**From:** Hoppe Kirsten  
**Sent:** Monday, October 07, 2024 2:30 PM  
**To:** Schick, Lesli J (DNR)  
**Cc:** Rupert Stephanie; Mamelli Brian; Jessica Fisher; Miller, Jessica A (DNR); Keppers Craig  
**Subject:** RE: [EXTERNAL] RE: New Well at ODS with Water Rights Established  
**Attachments:** Change Order Review for ODS Drinking Water System PWSID 2330024, Including Additional Well #6

**Re: Modification to Drinking Water System PWSID 2330024 at Eni Petroleum Oooguruk Drill Site (ODS) – Additional Source Well, Change Order to Request Dated July 8, 2024**

**Project Name:** ODS Water Source Well #6

8-27-24  
ODS, PROPOSED SW WELLS  
FOR REFERENCE ONLY

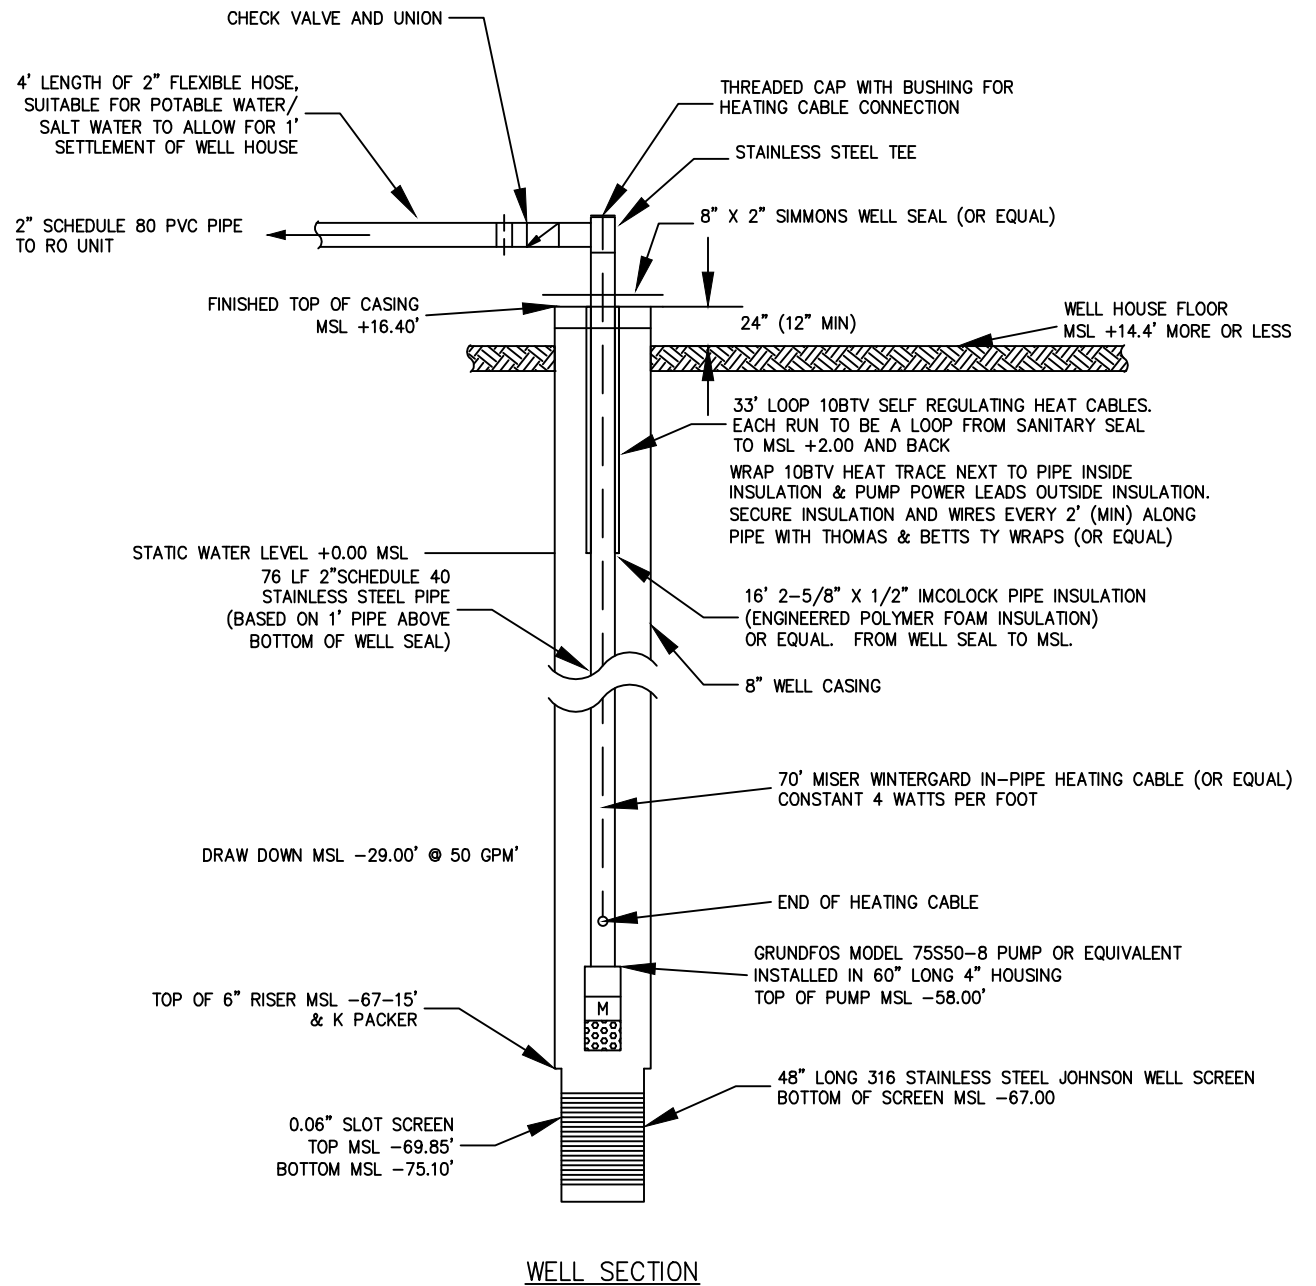
The new well will be placed approximately 20 ft south of the existing well #4. The new wells location is (see attached plan):

LAT: N 70 deg 29' 41.24"  
LONG: W 150 Deg 15' 03.28"

**Source Well (#6), change order review:**

The new well will be placed East of the Drilling Support Complex at ODS. The new wells location is (see attached plan):

LAT: N 70 deg 29' 43.87"  
LONG: W 150 Deg 15' 02.69"

**OFFSHORE SOURCE WATER FACILITY  
 PIPING & INSTRUMENT DIAGRAM (P&ID)**

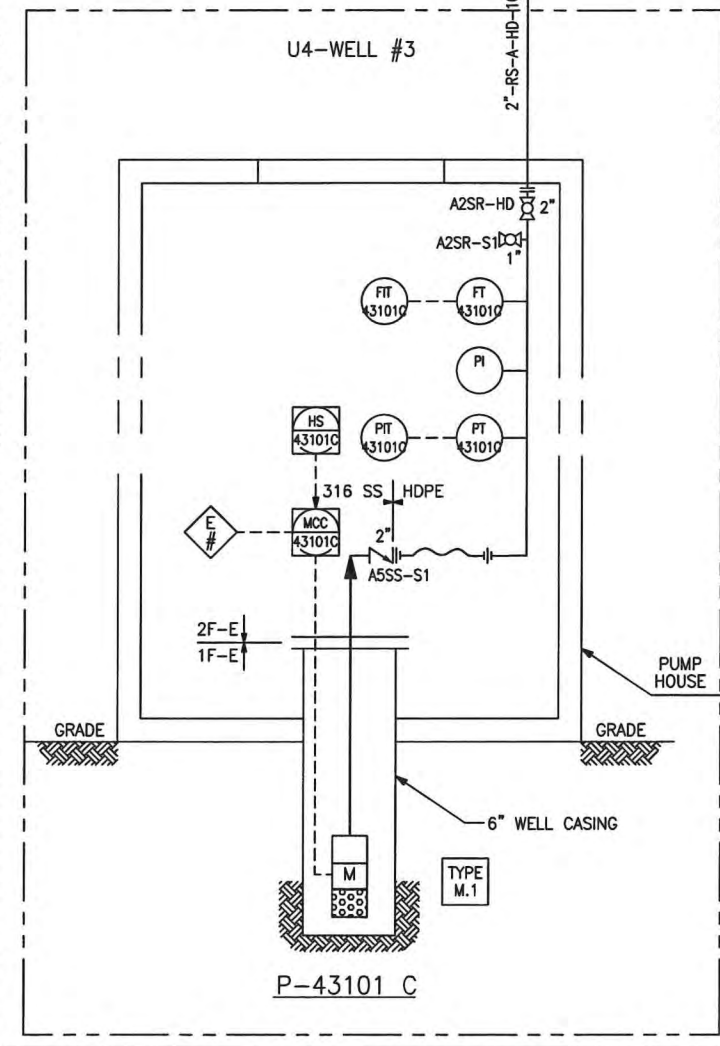
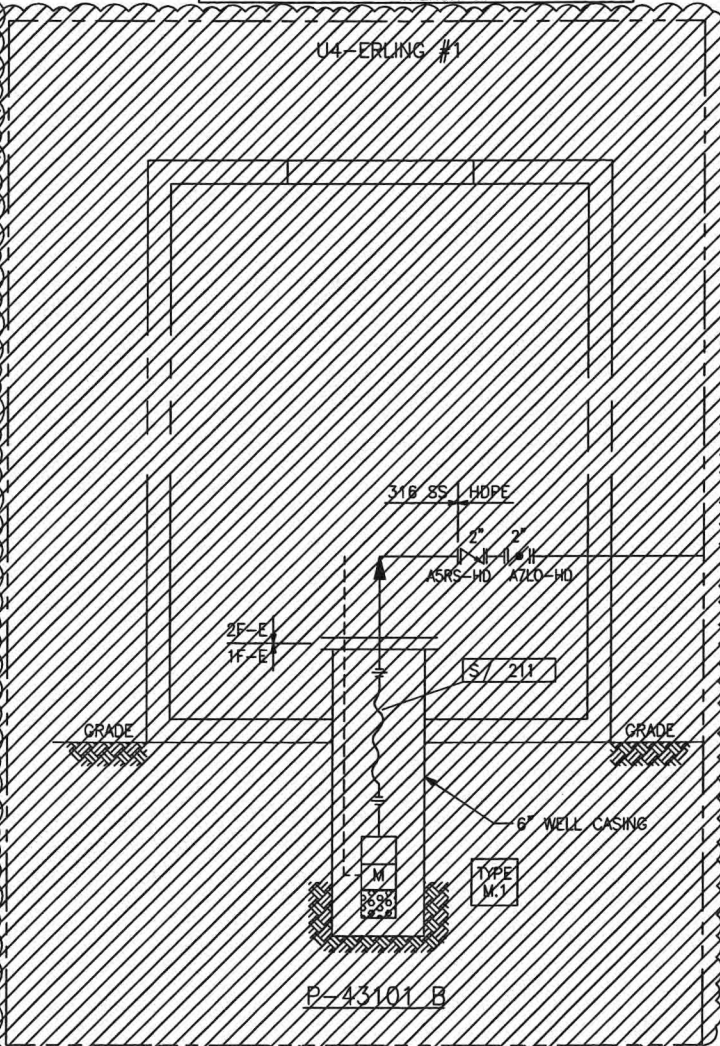
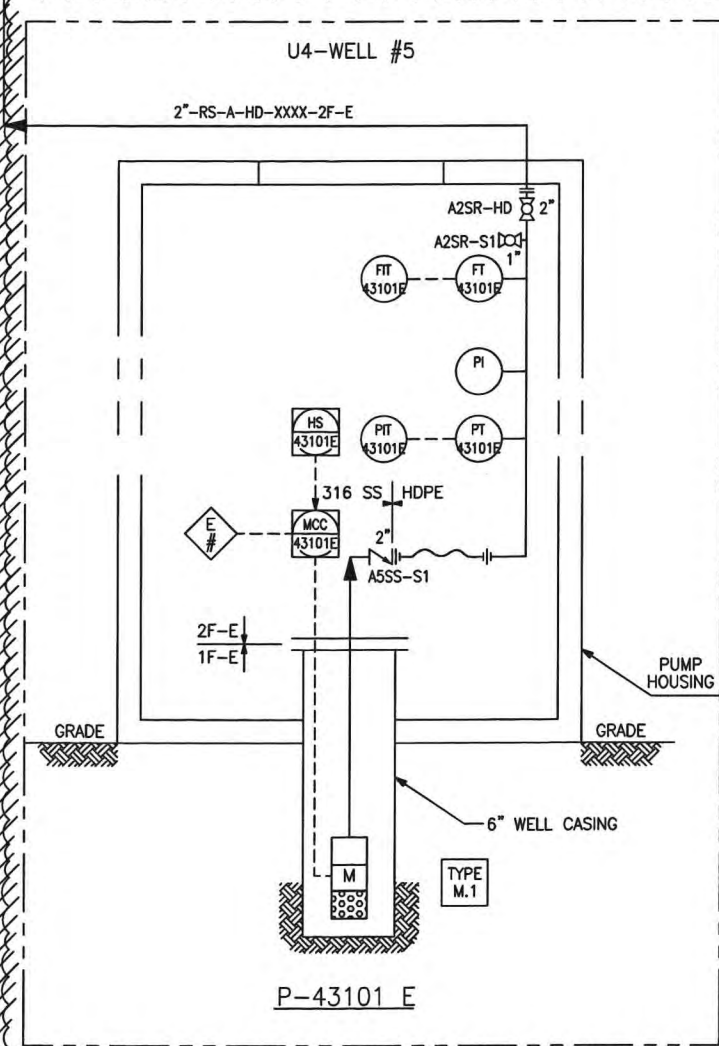
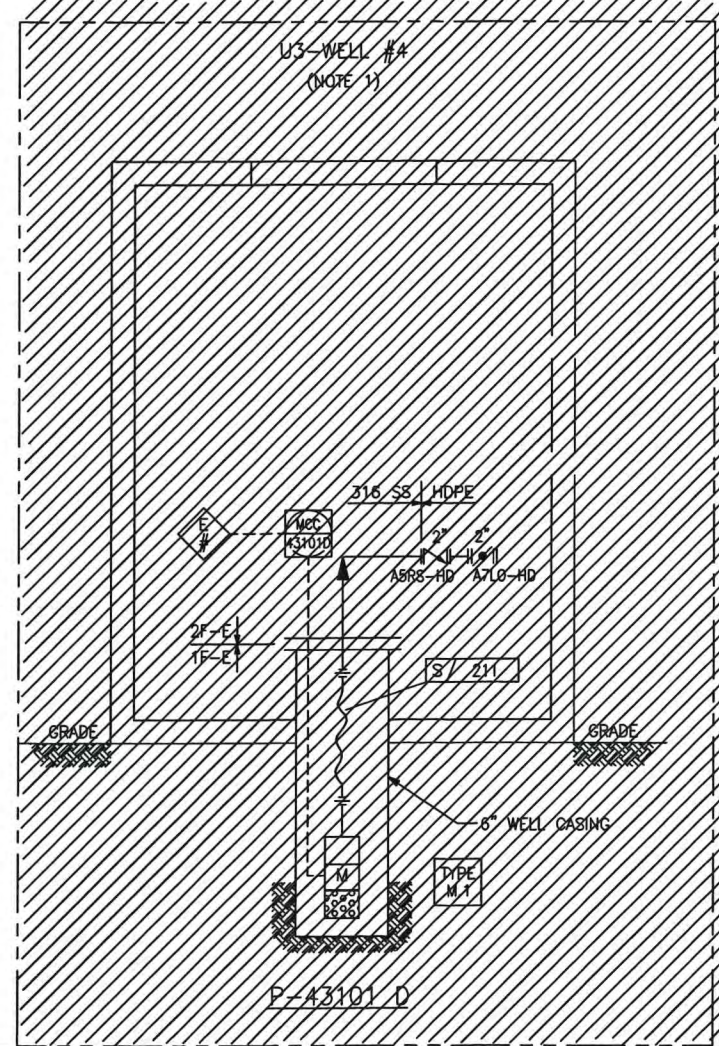
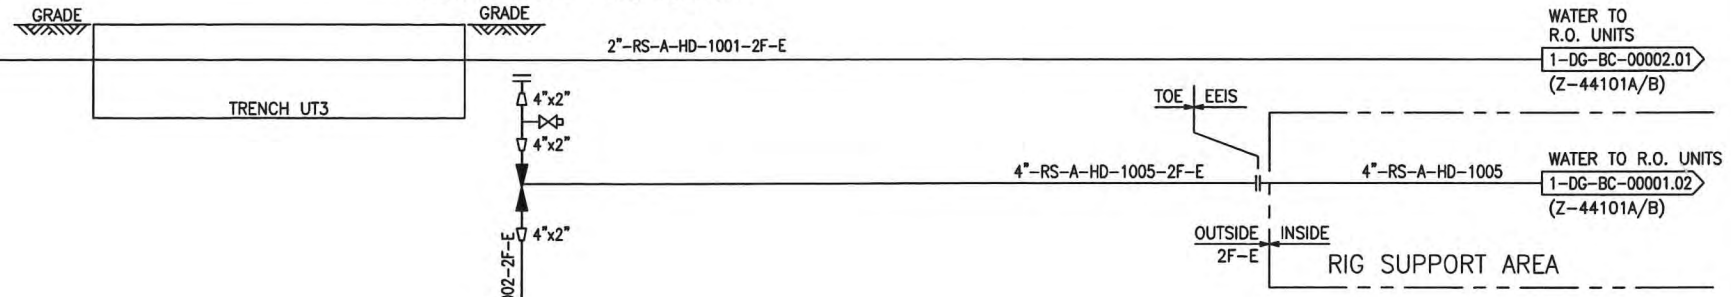
Failed wells #1 & #4 will be disconnected and abandoned. These wells are located at:

The new well (#5) will be tied into the raw water header in the location of the abandoned well #4 using the same materials as previously used.

**NOTE:**  
 1. WELL ERLING #2 HAS BEEN ABANDONED.  
 2. WELL ERLING #1 & 4 TO BE ABANDONED.  
 3. MODULE U3 TO BE REUSED FOR NEW WELL #5.  
 4. MODULE U4 TO BE REMOVED AND STORED.
